Aman Sweaters Ltd.

19 MARCH 2014

Observations Made

Removal of steel roof

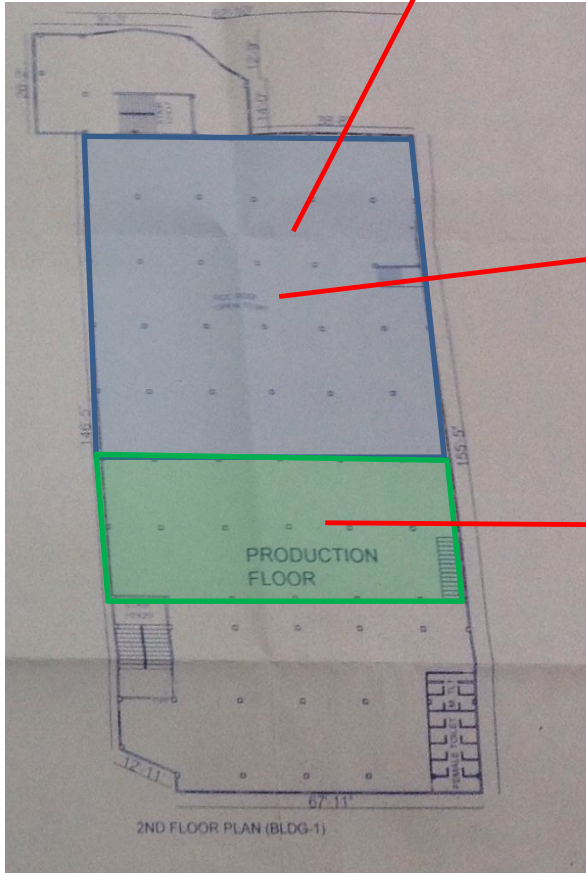
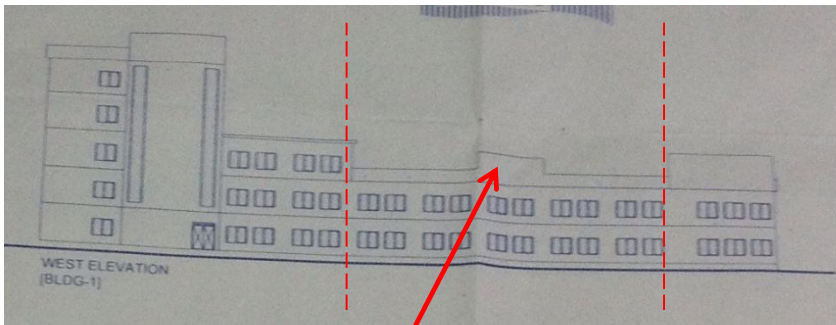
Steel roof structure was removed last year following a BGMEA inspection.

Steel structure not inspected; not visible due to suspended ceiling

Aggregate type and planned increases in column loads

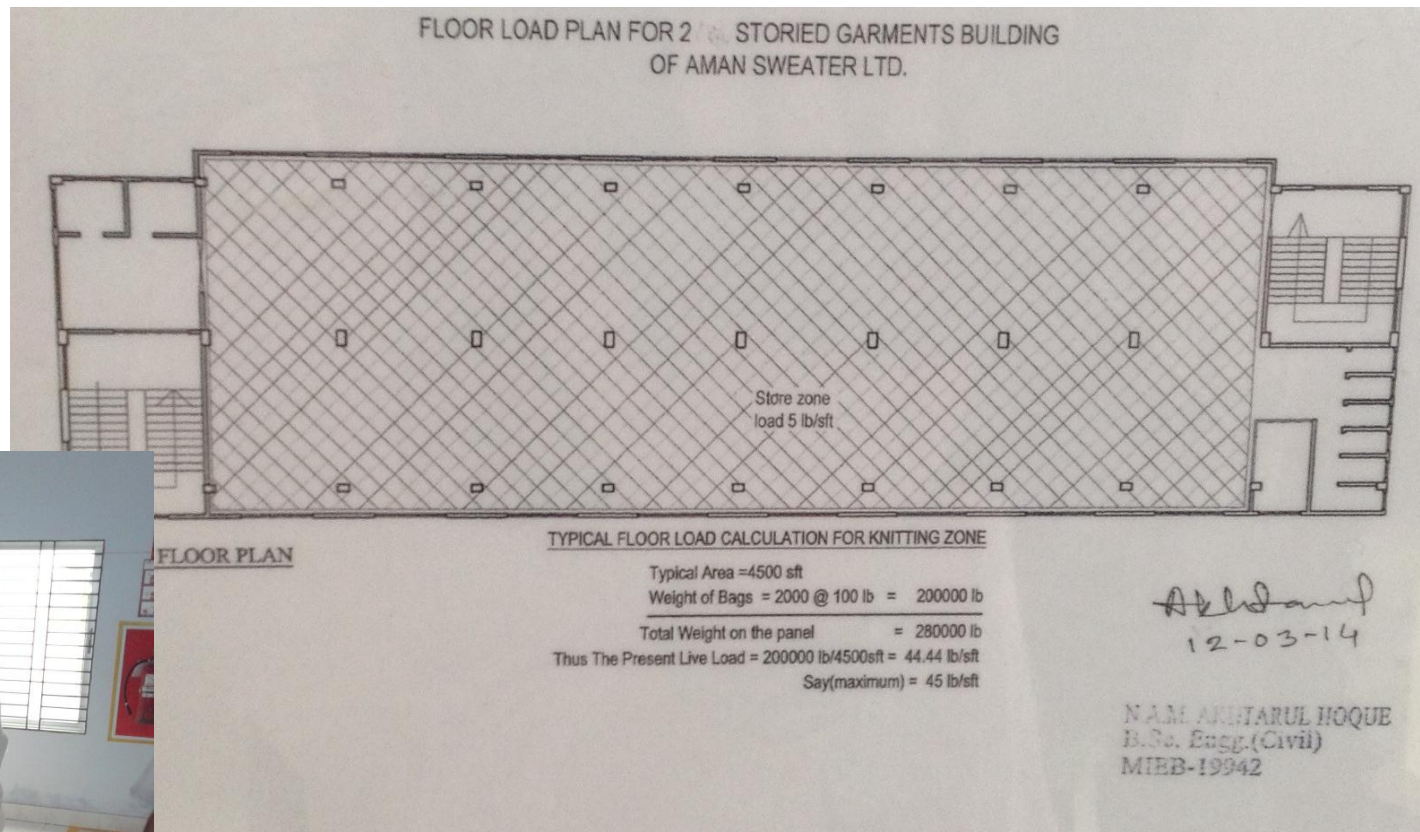
Starter bars extended above the roof of Building 2 for another storey to be added in the future.

Floor with heaviest load requirement should be placed on the ground floor where practical. Building Engineer to confirm capacity of floor slabs and columns.

No vertical extension of the building should commence without the correct engineering and permit approvals.

Aggregate type and planned increases in column loads

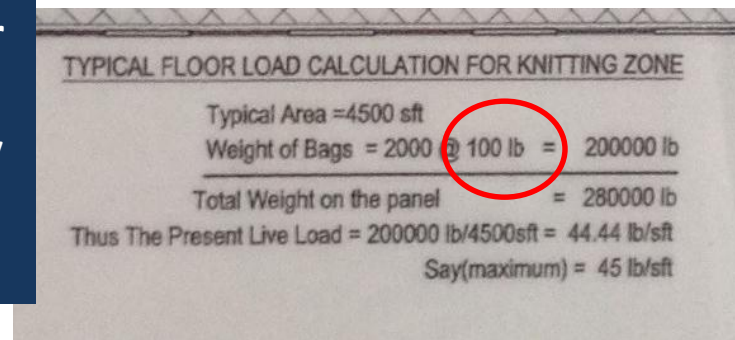
Brick aggregate discovered, understood to be stone.

Loading plans consider full floor area. An individual column may experience higher loading
